**EXPRESS TERMS
FOR
PROPOSED BUILDING STANDARDS
OF THE
CALIFORNIA STATE LANDS COMMISSION**

**REGARDING PROPOSED CHANGES TO
THE 2013 CALIFORNIA BUILDING CODE,
CALIFORNIA CODE OF REGULATIONS, TITLE 24, PART 2**

CHAPTER 31F – MARINE TERMINALS (MOT)

FIGURE 31F-4-2
PILE-DECK CONNECTION MODELING FOR
PRESTRESSED CONCRETE PILE
(ADAPTED FROM [4.2])

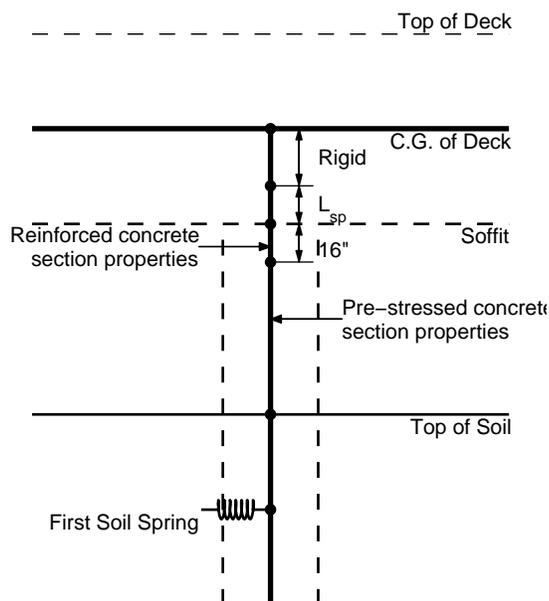
4.12. Add new Figure 31F-4-2:

**FIGURE 31F-4-4
IDEALIZATION OF PUSHOVER CURVE (ADAPTED FROM [4.3]).**

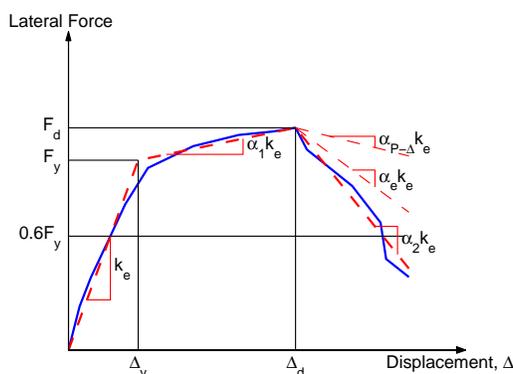
4.19. Add new Figure 31F-4-4:

FIGURE 31F-4-5
EFFECTIVE STIFFNESS, k_e [4.1]

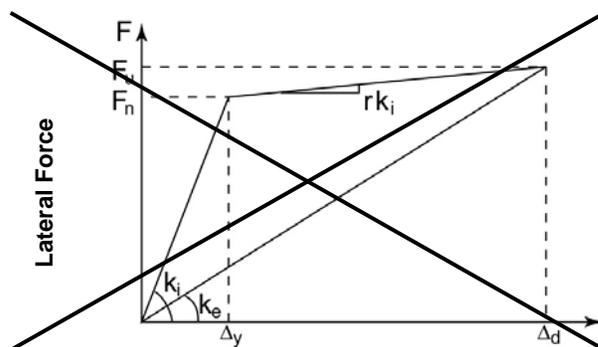
4.26. Remove entirely:

FIGURE 31F-4-7
LATERAL STIFFNESS (ADAPTED FROM [4.4])

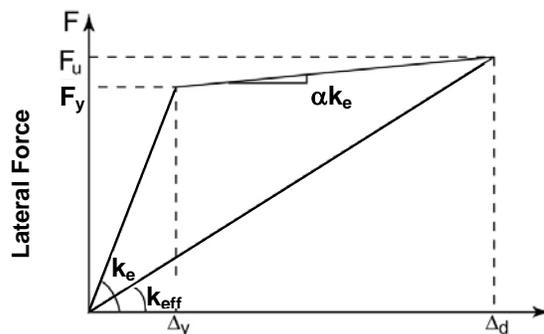
4.27. Add new Figure 31F-4-7:

FIGURE 31F-4-9
PLAN VIEW OF WHARF SEGMENT UNDER X AND Y SEISMIC EXCITATIONS

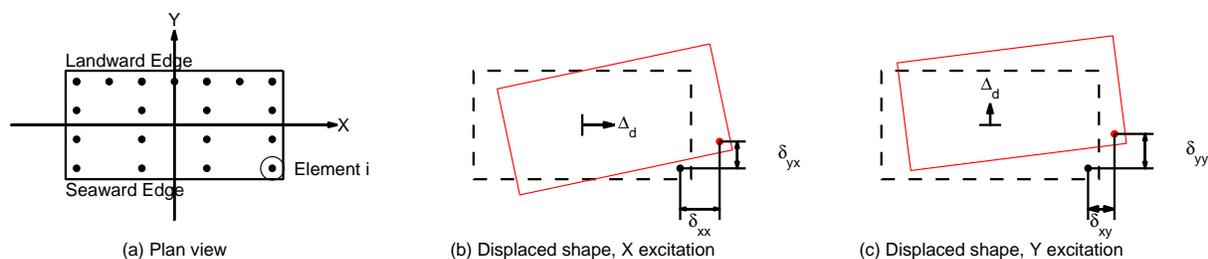
4.34. Remove entirely: **FIGURE 31F-4-7 PLAN VIEW OF WHARF SEGMENT UNDER X AND Y SEISMIC EXCITATIONS [4.3]**

4.35. Add new Figure 31F-4-9:

FIGURE 31F-6-1
AXIAL SOIL SPRINGS [6.8]

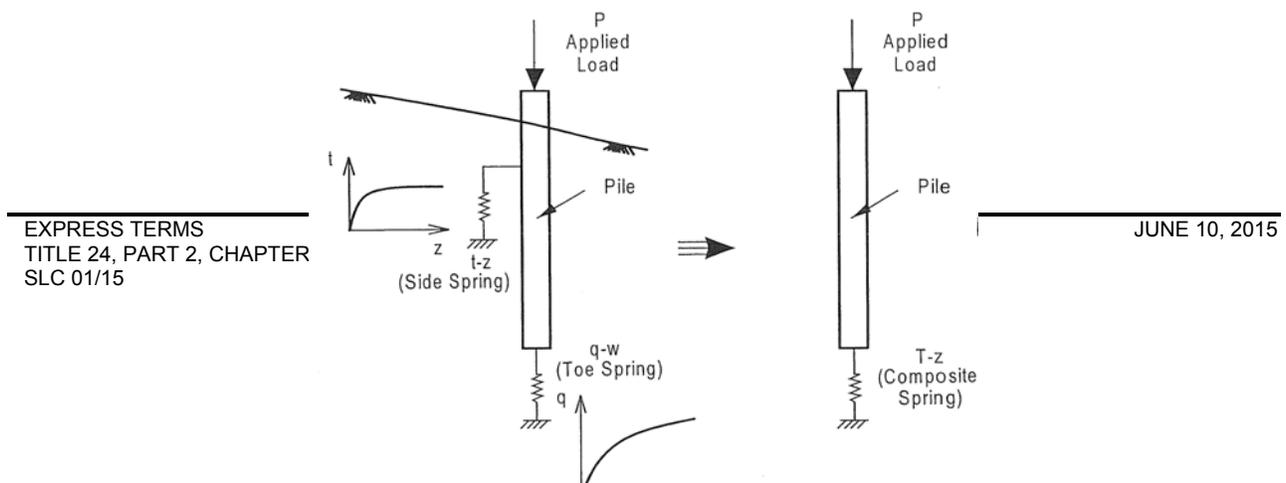
6.23. Add new Figure 31F-6-1 :

FIGURE 31F-6-2
SLIDING LAYER MODEL [6.8]

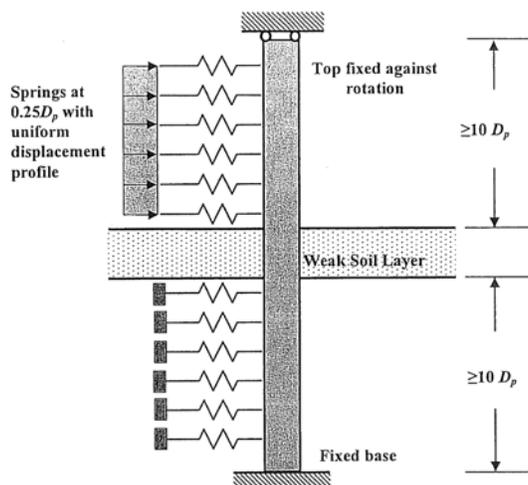
6.29. Add new Figure 31F-6-2 :

FIGURE 31F-7-4
INFLUENCE OF PILE/SOIL STIFFNESS RATIO ON PLASTIC HINGE LENGTH (after Fig 5.30 of [7.1])

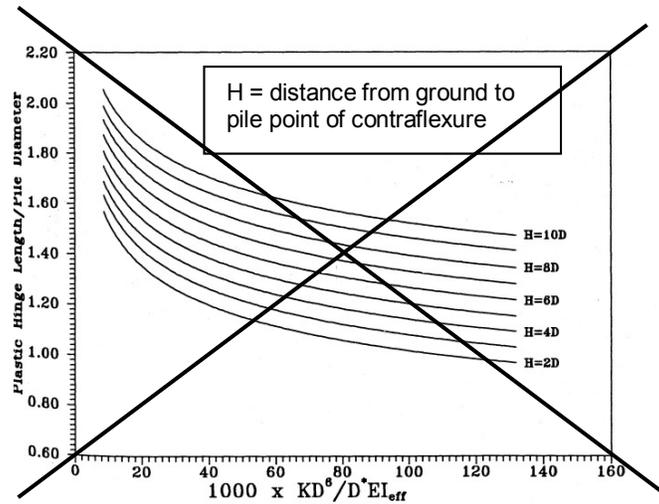
7.2. Remove entirely:

**FIGURE 31F-7-4 31F-7-5
METHOD A – MOMENT CURVATURE ANALYSIS**

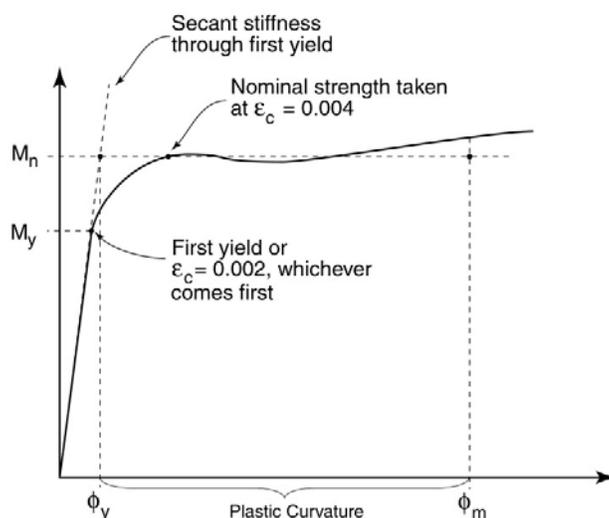
7.7.

FIGURE 31F-7-5
METHOD B – MOMENT CURVATURE ANALYSIS [7.6]

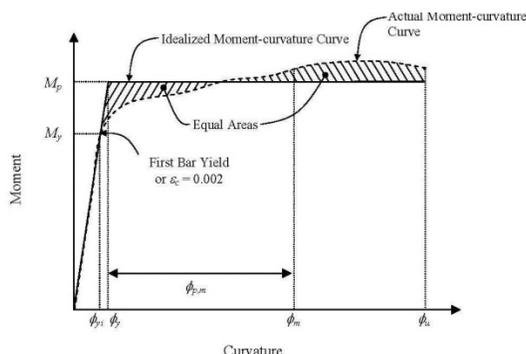
7.9. Add new Figure 31F-7-5:
